SPROWSTON:
BLUE BOAR LANE CYCLE FACILITY

STAGE 2 SAFETY AUDIT

REPORT REF: C256/006
May 2020

6.0 Problem Location Plan

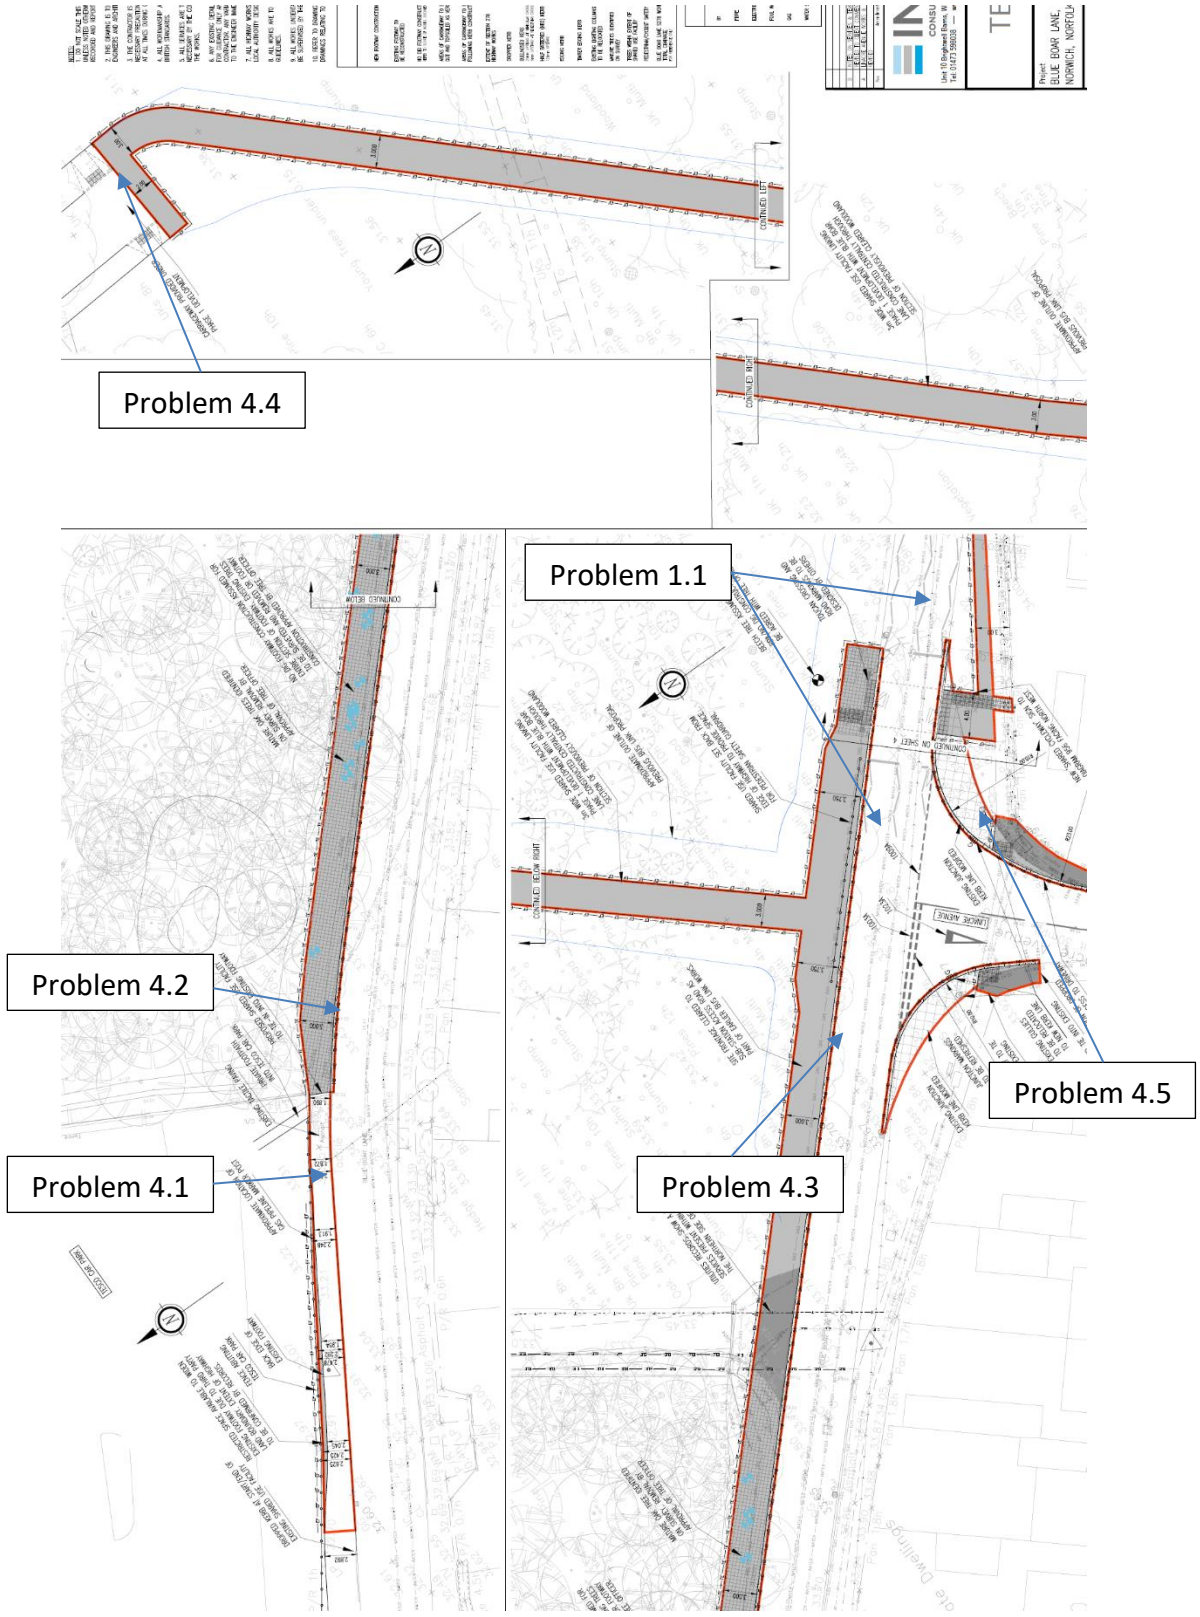
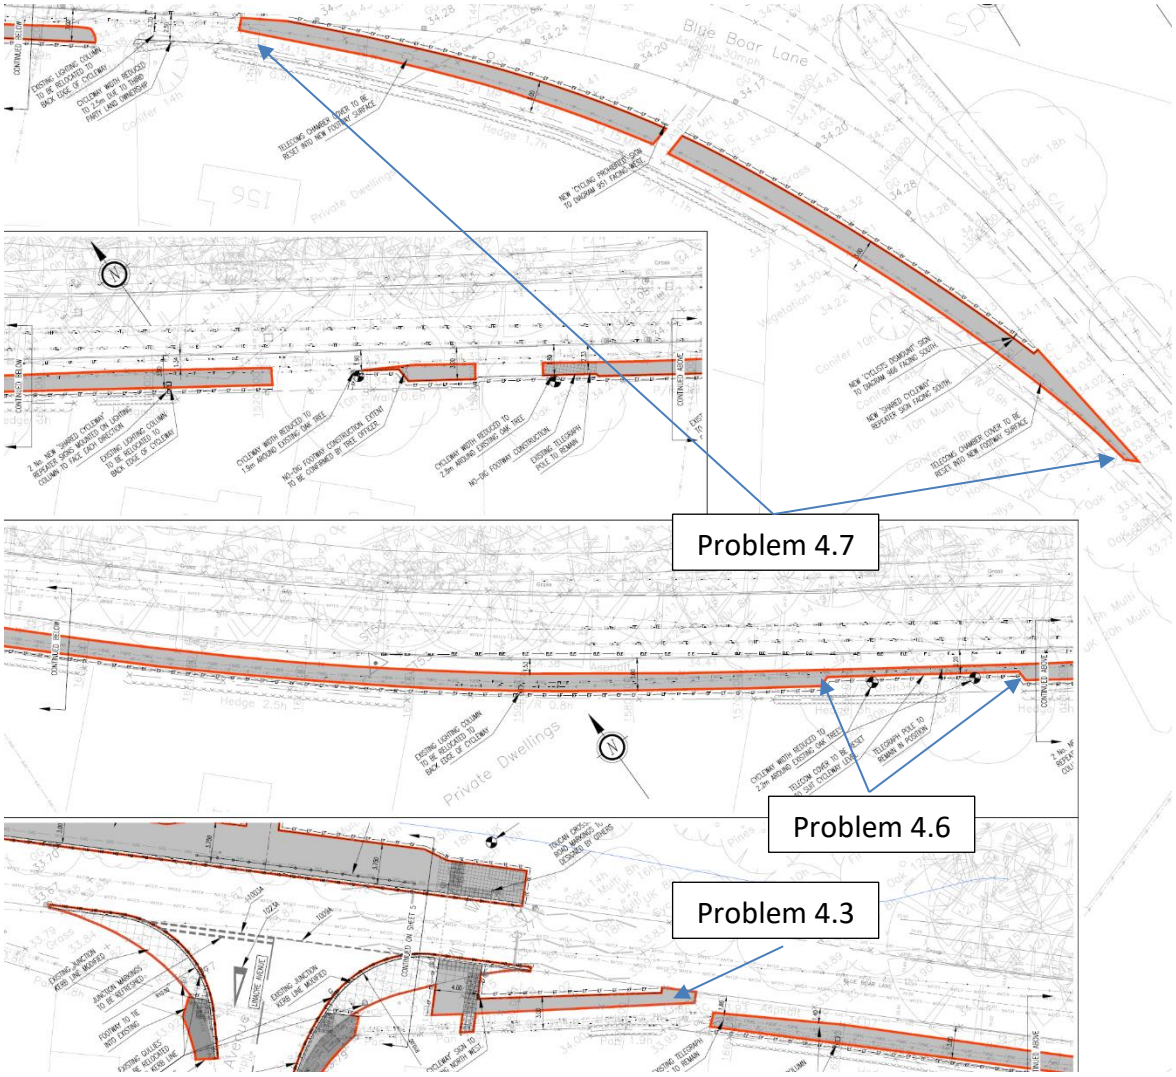
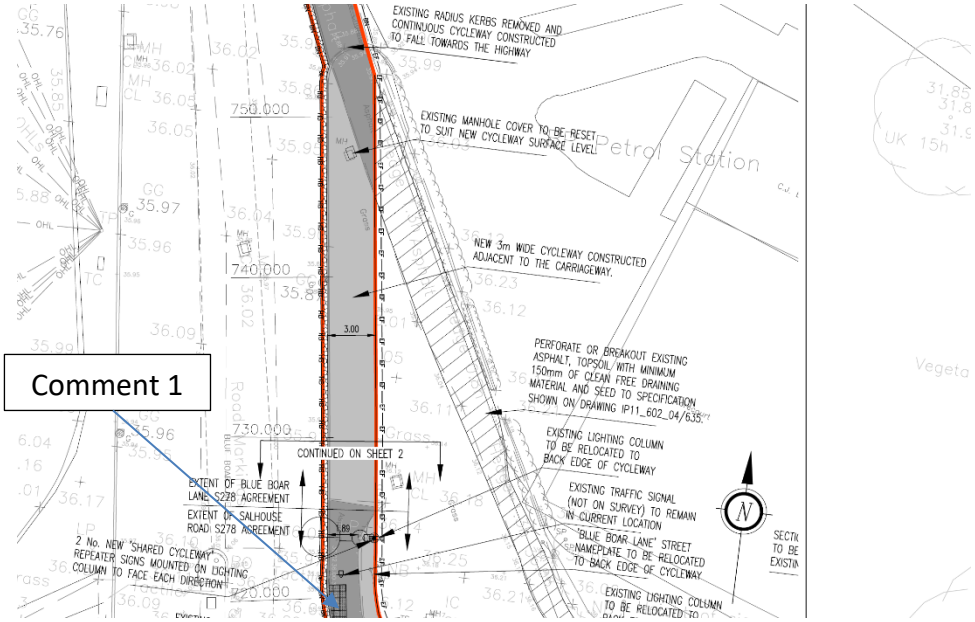
Adequate skidding resistance is of upmost importance on the approach to controlled crossings where sudden and harsh braking may be expected. An absence of adequate skidding resistance increases the risk of conflict with crossing users and tail end collisions.

The width of part of the proposed facility adjacent to the Tesco store is below that acceptable for a shared use facility. This presents a risk of conflict between cyclists and pedestrians.

The proposed facility is too narrow at the southern edge of the Tesco site boundary (see Problem 4.1). A dropped kerb is present at the current termination point. Given the recommendation to Problem 4.1 it is considered likely that some cyclists will exit the facility at this point. However, no facility is present to allow them to rejoin.

There is a lack of guidance for road going cyclists on approach to the proposed crossing. This increases the risk of unsafe manoeuvring in the carriageway.

A tactile pram crossing is proposed at the tie in to the existing housing estate. The reasoning behind this is unclear. This has resulted in a narrow dropped kerb which a cyclist must manoeuvre around at a sharp angle in order to access the proposed facility. This increases the risk of loss of control and a rider falling from their bicycle.

It is reasonable to expect cyclists on Linacre Avenue to wish to use the proposed crossing. However, no facility is provided for them to access the crossing. This presents a risk of either illegal usage via the footway crossing point, or of attempting to bump up the kerb with a risk of loss of control and conflict with turning traffic.

A narrowing is proposed in the vicinity of the two mature oak trees. The reason for this narrowing is understood and agreed with. However, the Auditors are concerned that the reduced width section is longer than necessary, increasing the risk of conflict.

Significant vegetation is present around this bend such that it may obstruct visibility to the north for cyclists exiting the facility in a southbound direction. Furthermore, some of the vegetation appears to be low enough to pose a risk of head strikes by passing cyclists.

Agreed. The approaches to the crossing are to be resurfaced with 60 PSV material.

No further land is available so 'Cyclists Dismount' signs have been added. The existing vegetation is also noted as to be crown lifted to 2.5m.

Agreed. Dropped kerbs are provided to allow cyclists to re-join the shared use facility.

Agreed. Dropped kerbs and marking have been added in the locations suggested.

Agreed. The tactile crossing has been omitted and a longer run of dropped kerb is proposed.

Agreed. Additional dropped kerbs have been provided and the south side of the Linacre Avenue junction area is signed as shared use facility.

Agreed. The shared use facility has been revised to employ a larger area of no-dig construction methods to enable a greater area to be surfaced.

Agreed. Noted on scheme drawings.
